# PCN-20180511 TE0841-01 to TE0841-02 Hardware Revision Upgrade

<b>Company</b>	Trenz Electronic GmbH
<b>PCN Number</b>	PCN-20180511
<b>Title</b>	PCN-20180511 TE0841-01 to TE0841-02 hardware revision upgrade
<b>Subject</b>	Hardware revision 01 to 02
<b>Issue Date</b>	20180511

### #1 Change SPI Flash from N25Q256A11E1240E to N25Q512A11G1240E

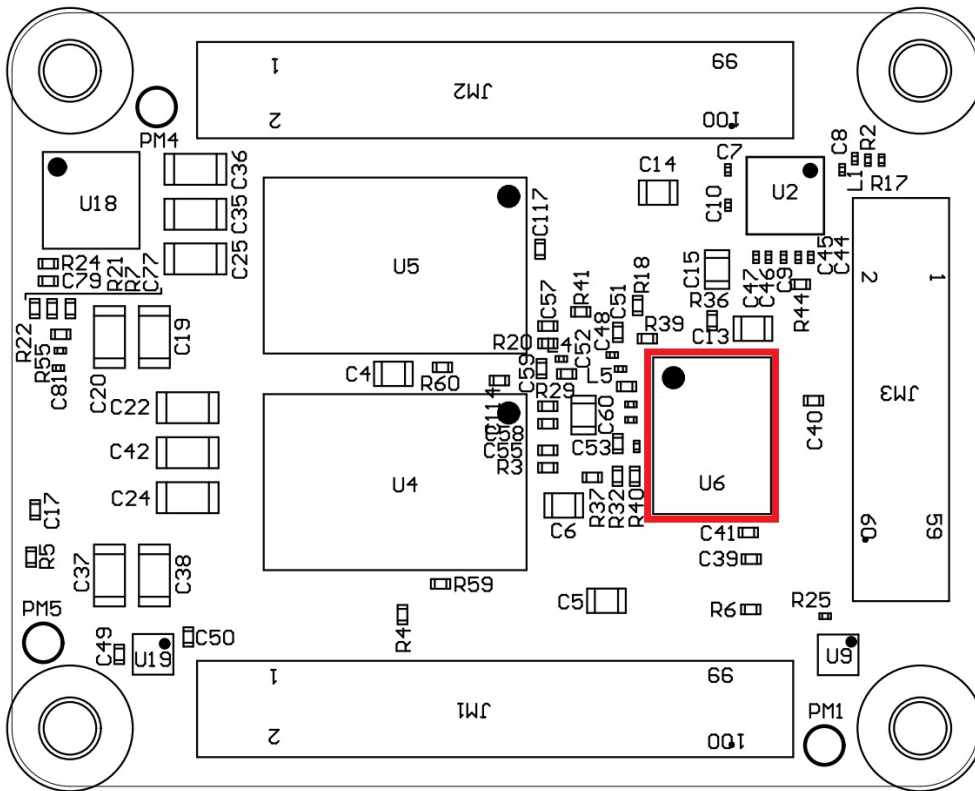
**Reason:** N25Q256A11E1240E became obsolete, the replacement part is not available for purchase. This is only an interim solution, because N25Q512A11G1240E is also obsolete already. It will be changed after the replacement parts will be available.

**Impact:** size changed from 256 MBit to 512 MBit per chip. JEDEC ID changed from BB19h to BB20h, both with manufacturer ID 20h.

Locate Flash on backside of PCB:

N25Q256A11E1240E

N25Q512A11G1240E
